Quality Control Check Report. Stage: After Plumbing & Electrical (Apartments)

Flat No.	A-418	Other	-	Sl. No.	41829
Company	M R G V	Project	B R G V	Phase	-
Prepared by	P. Bhargava	Sign	P.B.	Date	19-05-23
Project Manager	Sarwan	Sign	Syulgha	Date	19-05-23
Previous stage report no.	41609	Report filed and signed by PM?	☒ Yes ☐ No		
Additions & alterations sheet date	15/04/22	All pages signed by engineer & customer?	☒ Yes ☐ No		
Checked By MD on		MD Sign		For filling	☐ Yes ☐ No

Quality Control Check Report. Stage: After Finishing Stage II (Apartments)

Quality Control Check Report. Stage: After Brickwork (Apartments/ Lab Spaces)

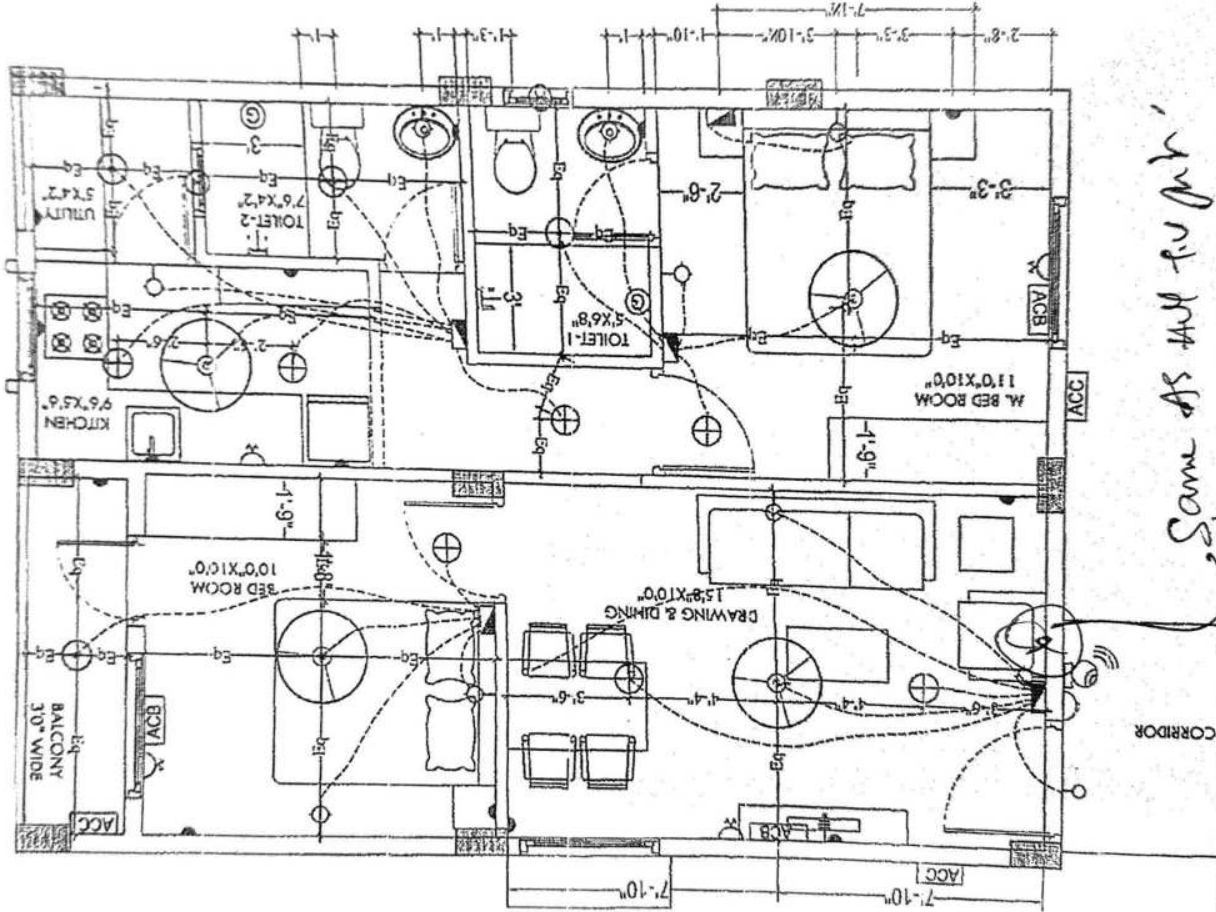
ges in electrical points: (mark on plan)

① 16 Amp Rcd.

② 16 Amp Rcd.
